Access Compliance Report

Public Rights-of-Way

Intersection ID: 31683	Main Street: GALLISON_AV	Cross Street: WILLIE_WORRELL_DR	Location: NE
ADA ID: 8C2D62CE2D94	Ramp Type: PerpDiag	Initial Pass/Fail: Fail	Overall Compliance: No
Severity Score: 18.75			
Codes/Mitigation Info/Possible Solution		Field Measurements/Component Compliance

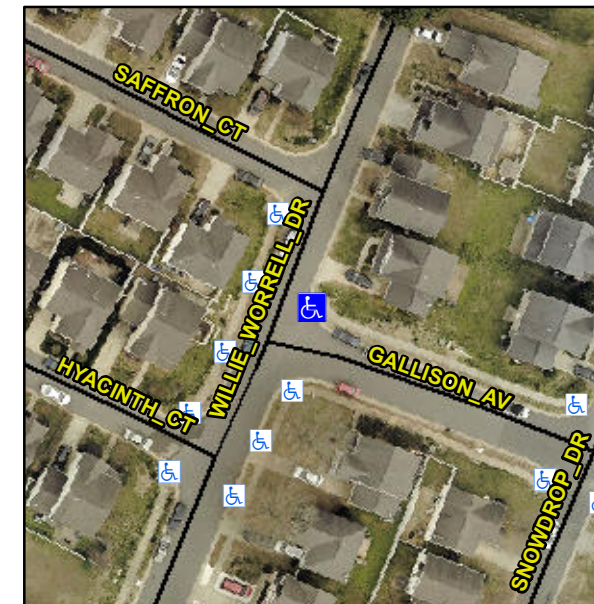
Not Found, R304.5.1, R304.5.3

Compliance	Description	Data	Compliance	Description	Data
N/A	Ramp Length (in)	51.0	Yes	Ramp Slope (%)	5.2
No	Ramp Width (in)	35.0	No	Ramp XSlope (%)	4.8
N/A	Flare Type LT	N/A	N/A	Flare Type RT	N/A
N/A	Flare Slope LT (%)	N/A	N/A	Flare Slope RT (%)	N/A
N/A	Flare Traversable LT?	N/A	N/A	Flare Traversable RT?	N/A
N/A	Landing Length (in)	N/A	N/A	DWS Provided?	N/A
N/A	Landing Width (in)	N/A	N/A	DWS Contrast?	N/A
N/A	Landing Slope (%)	N/A	N/A	DWS Length (in)	N/A
N/A	Landing X Slope (%)	N/A	N/A	DWS Full Width?	N/A
N/A	Landing Curb? (Y/N)	N/A	N/A	DWS Offset (in)	N/A
N/A	Shared Landing?	N/A			
N/A	Gutter Ponding?	N/A	N/A	Gutter Slope (%)	N/A
N/A	Gutter Lip Ht (in)	N/A	N/A	Gutter X Slope (%)	N/A
N/A	Painted X Walk1?	No	N/A	Painted X Walk2?	No
	X Walk 1 Direction	To NW		X Walk 2 Direction	To SW
N/A	X Walk 1 Width (in)	N/A	N/A	X Walk 2 Width (in)	N/A
	X Walk 1 Slope (%)	0.8		X Walk 2 Slope (%)	2.0
	X Walk 1 X Slope (%)	4.7		X Walk 2 X Slope (%)	0.6

Remove & Replace Curb Ramp With Two New Directional Ramps or Equivalent.
